MACTRIS REV. B NIM MODIFICATIONS

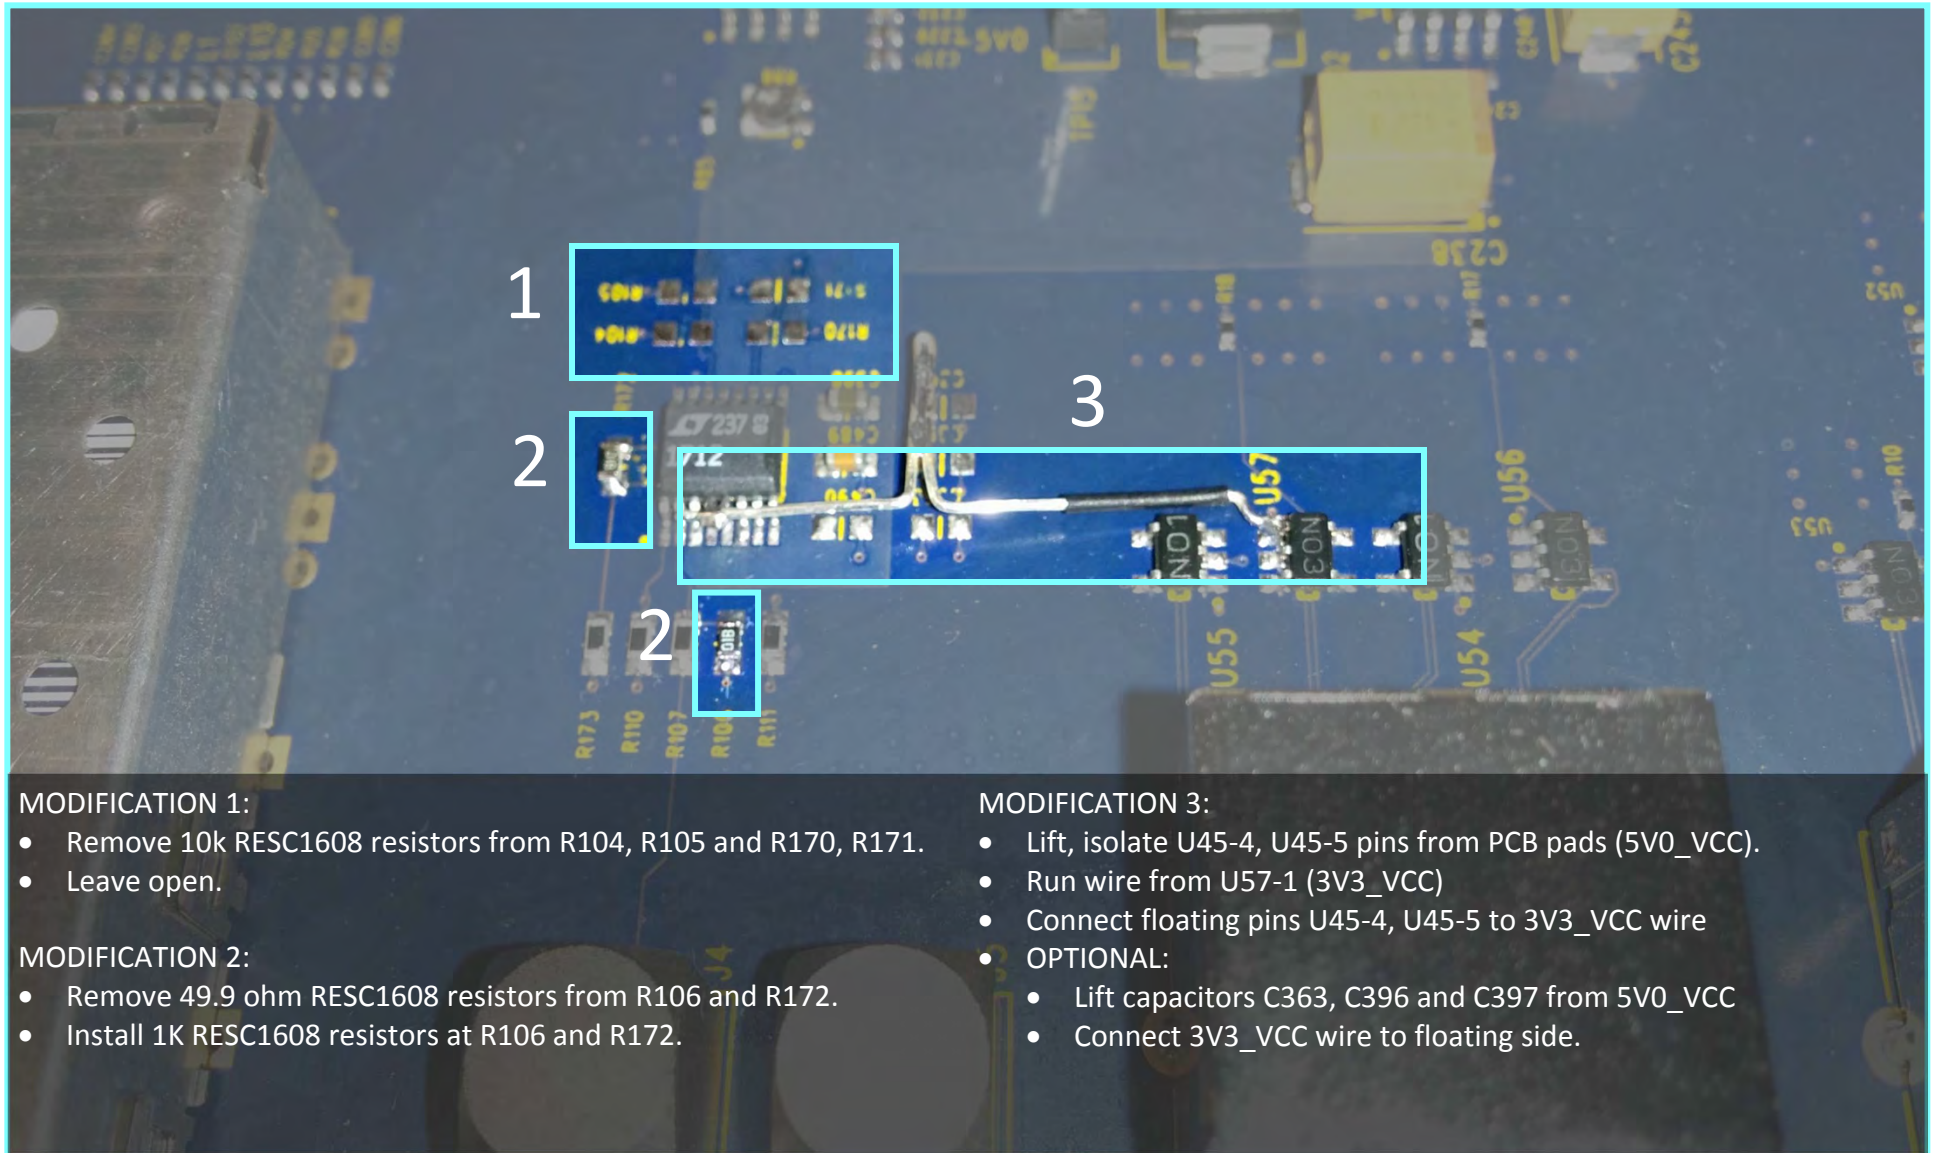
- Remove 10k RESC1608 resistors from R104, R105 and R170, R171.
- Leave open.

- Remove 49.9 ohm RESC1608 resistors from R106 and R172.
- Install 1K RESC1608 resistors at R106 and R172.

- Lift, isolate U45-4, U45-5 pins from PCB pads (5V0_VCC).
- Run wire from U57-1 (3V3_VCC)
- Connect floating pins U45-4, U45-5 to 3V3_VCC wire
- OPTIONAL:
 - Lift capacitors C363, C396 and C397 from 5V0_VCC
 - Connect 3V3_VCC wire to floating side.
